INSPECTION REPORT
Sedimentation Structure
N2-RC
Kayenta Mine
Navajo County, Arizona
for
PEABODY COAL COMPANY

Dames & Moore
10139-011-22

SITE PLAN
N2-RC

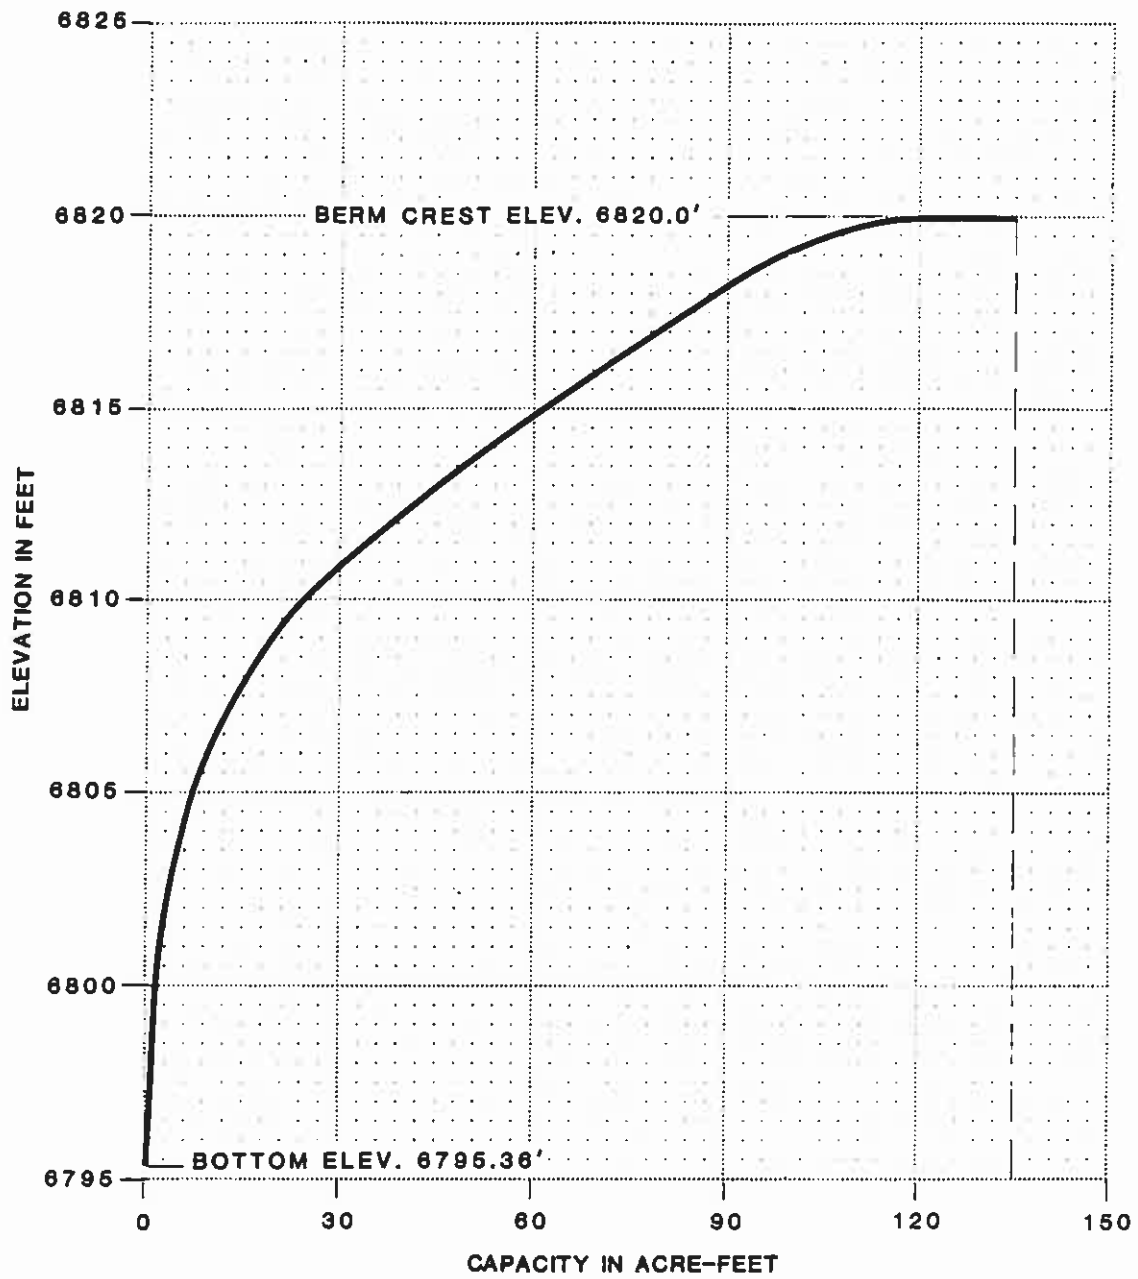
Structure N2-RC needs three low berms constructed at the locations shown on Plate 1, Site Plan N2-RC. The berms may be constructed out of suitable plant growth material at flat, gentle slopes to blend in with existing slopes. No stability analyses were performed on these berms and although, some settlement due to the weight of the berms may occur it is our opinion that these berms will be stable. Some localized sloughing and settlement cracks may develop during the life of this structure, however, these are considered a periodic maintenance task.

PROPOSED BERM

PROPOSED BERM

NOTE:
BERM SLOPES TO BLEND
WITH EXISTING SLOPES
